Delegated officer report for planning application

Application no. 136510/LP/2023
Date registered valid: 17 March 2023
Proposal: Erection of a single storey rear extension following demolition of existing conservatory
Address: 1428 Ashton Old Road, Manchester, M11 1HL
Ward(s): Clayton & Openshaw Ward

Recommendation: REFUSE
Date of recommendation: 9 May 2023

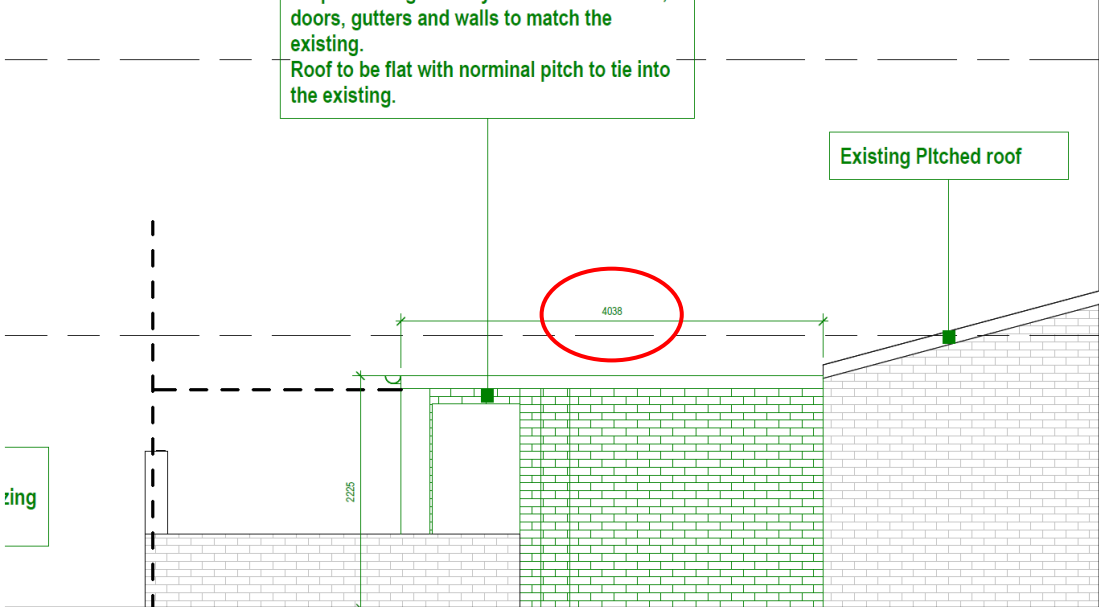
(i) extend beyond the rear wall of the original dwellinghouse by more than 4 metres in the case of a detached dwellinghouse, or 3 metres in the case of any other dwellinghouse, or	No
<u>Explanation</u> The submitted drawings show that the proposed rear extension would have a rearward projection of over 4 metres. As the property is an end terraced the reward projection cannot exceed 3 metres and therefore the proposal does not comply with A.1(f)(i)  The diagram is a cross-section of a building extension. It shows an existing brick wall on the right with a pitched roof. A new extension is shown to the left, with a flat roof. A dimension line indicates a horizontal projection of 4038mm from the existing wall to the new extension. Another dimension line indicates a vertical height of 2225mm for the extension. Annotations in green text state: 'doors, gutters and walls to match the existing. Roof to be flat with normal pitch to tie into the existing.' and 'Existing Pitched roof'. A dashed line on the left indicates the original building line. A small box on the left contains the word 'wing'.

Image 1: A section of an ONS Map dated 1950 showing original dwellinghouse layout as highlighted in the red box, the yellow arrow shows the properties 1434 and 1436 Ashton Old Road that have a similar layout.

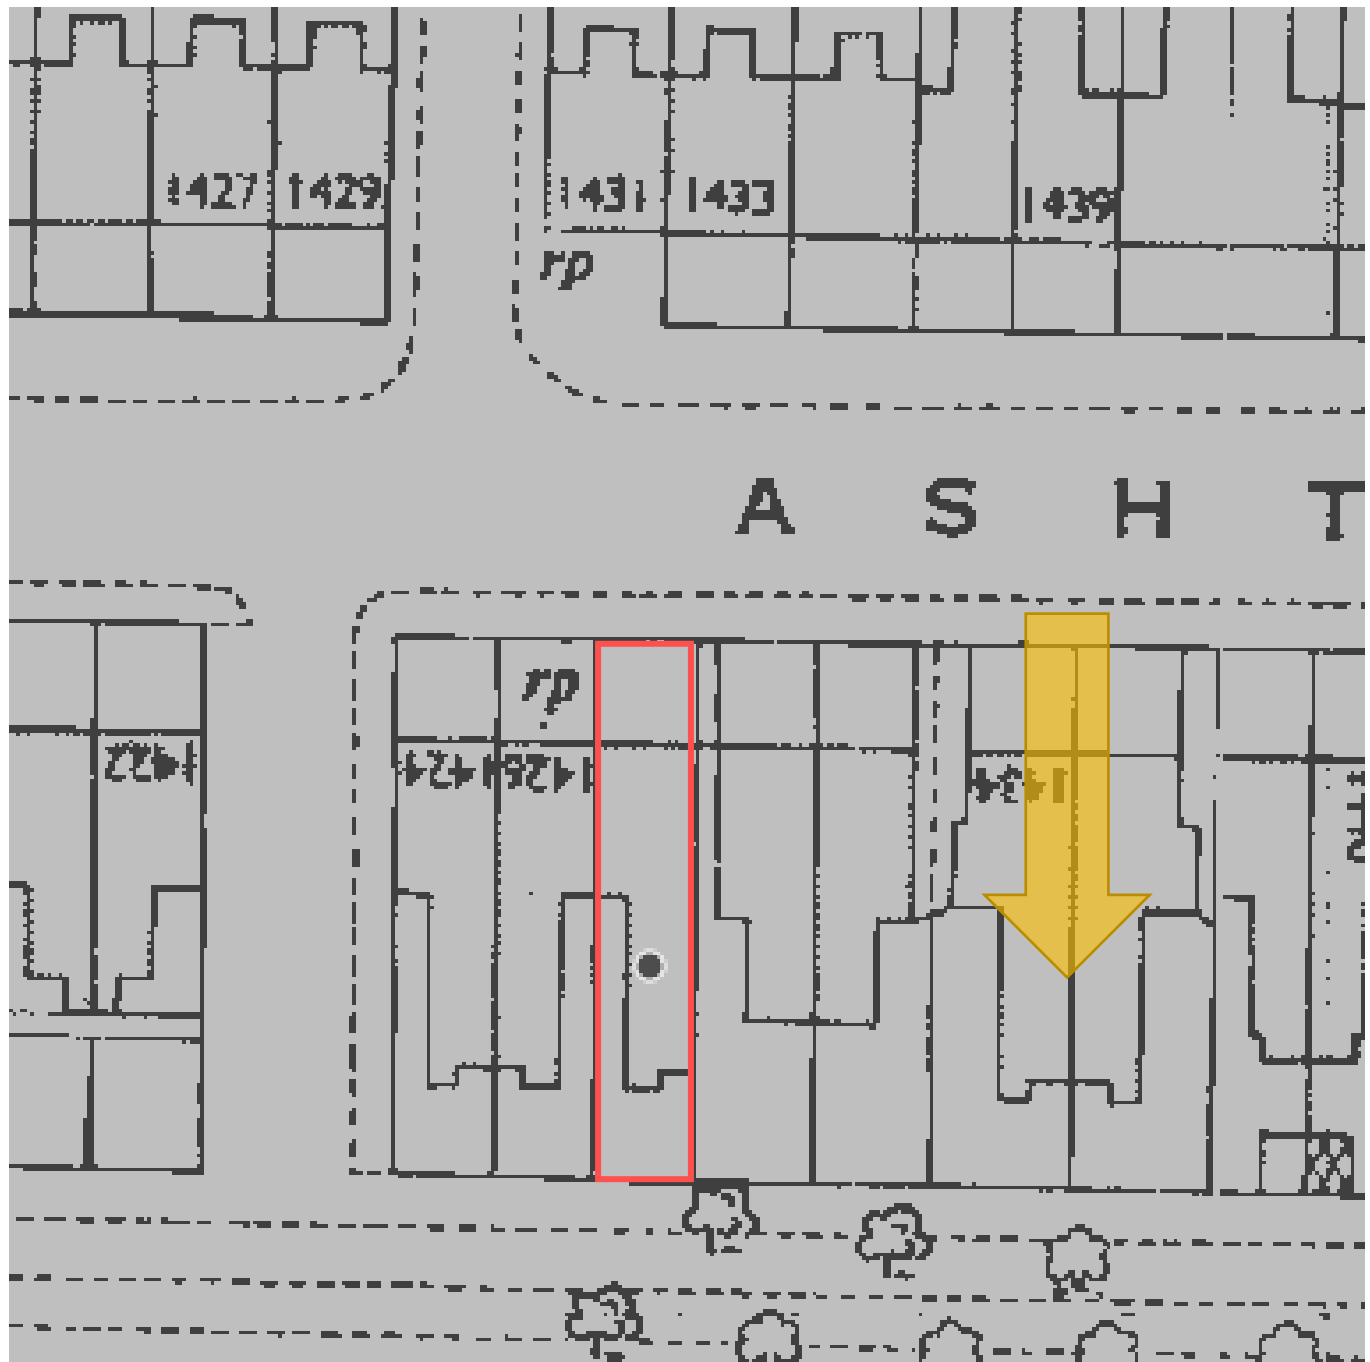
A.1 (j) the enlarged part of the dwellinghouse would extend beyond a wall forming a side elevation of the original dwellinghouse, and would— (i) exceed 4 metres in height,	N/A
(ii) have more than a single storey, or	N/A
(iii) have a width greater than half the width of the original dwellinghouse; or	No
<u>Explanation</u> Image 1 taken from 1950s ONS map shows the original layout of the building, on the 1950s map this layout is repeated at 1424, 1426, 1434 and 1436 Ashton Old Road. Image 2 shows the most recent aerial image of the site and neighbouring properties taken from Google Earth, the image reveals that the to the side of the small outriggers have been infilled at 1424, 1426 and 1428 but have remained at 1434 and 1436. By comparing both images it is more than likely that the outriggers were removed, however despite the removal they would remain part of the original floor plan, as discussed earlier within the report under the Order, the term "original" means: <i>in relation to a building existing on 1st July 1948, as existing on that date and, in relation to a building built on or after 1st July 1948, as so built</i> Therefore, this part of property also requires consideration when assessing the proposal. Image 3 shows the approximate position of the infilled and the orange lines indicates the likely position of the original side wall.

Whilst the small outrigger would be not be reinstated or modified as part of the proposal, the development would consequently, extend beyond a wall forming a side elevation of the original dwelling. Therefore, as proposal would form an extension beyond the side wall (indicated as a orange line) resulting in an overall width of 4.04 metres and therefore the extension if built would have a greater width than half the width of the dwellinghouse and would not comply with A.1 (j)(iii) of the GPDO.

Image 3 Proposed and existing ground floor plan drawing

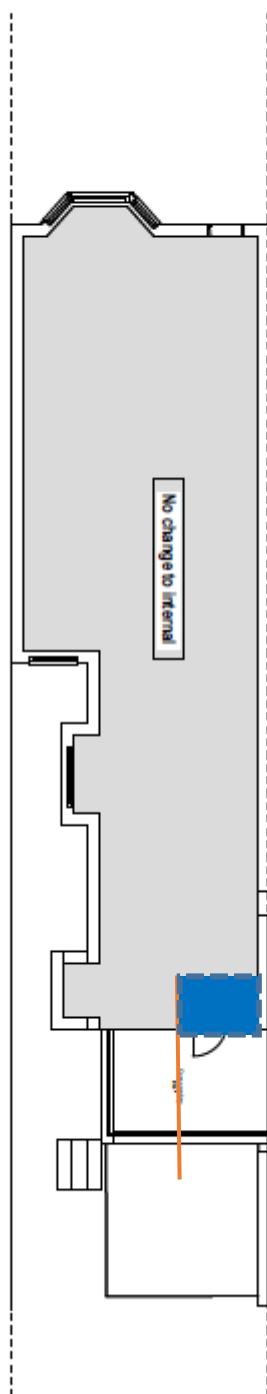
The blue box (above) has at some time after 1948 been infilled to extend the property rearward; this extension will then join to the proposed extension and the result would exceed the limits of (e) to (j)

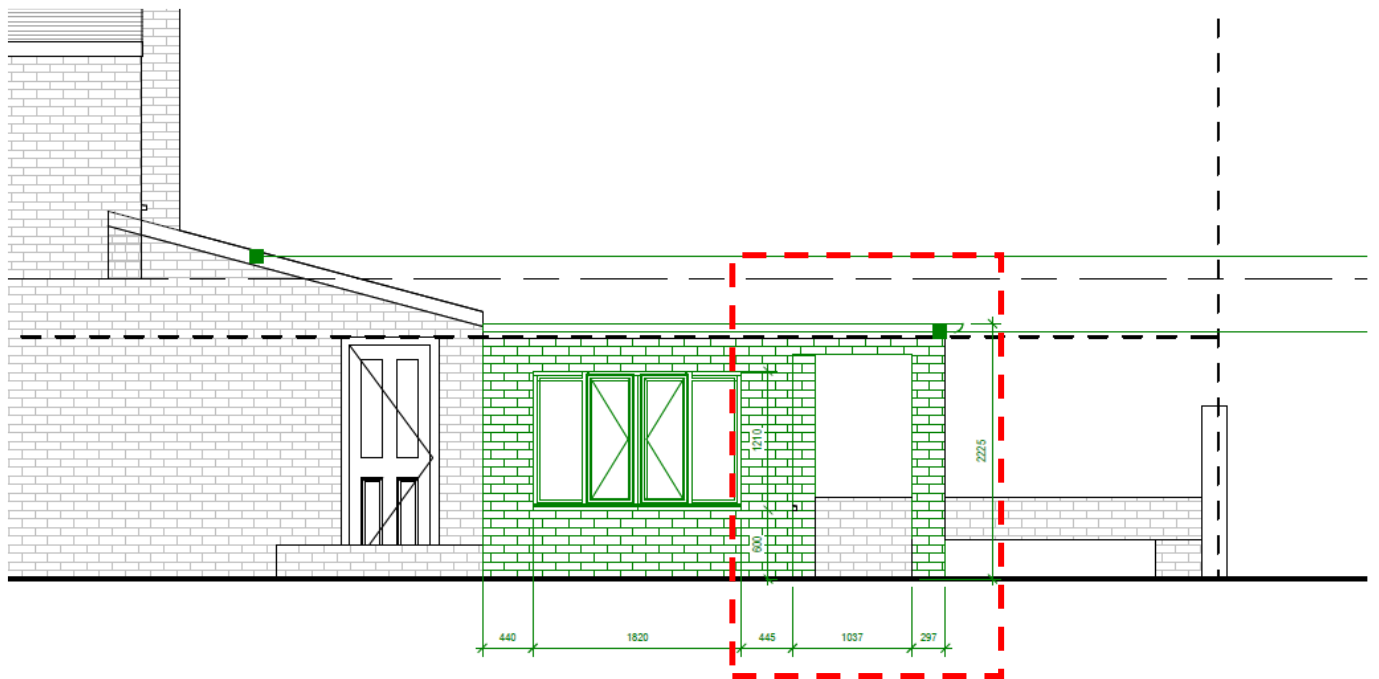
Verandahs, balconies and raised platforms are not permitted development under Class E. 'Verandah' and balcony' are discussed in detail on page 29 of the Permitted Development Rights for Householders – Technical Guidance document (September 2019). The drawings show a roofed and partially enclosed area that is incorporated into the proposal, in accordance with page 29 of the guidance defines a veranda as a gallery, platform, or balcony, usually roofed and often partly enclosed, extending along the outside of a building at ground level. It is considered that this is the case with this proposal and therefore would not comply with A.1 (k).
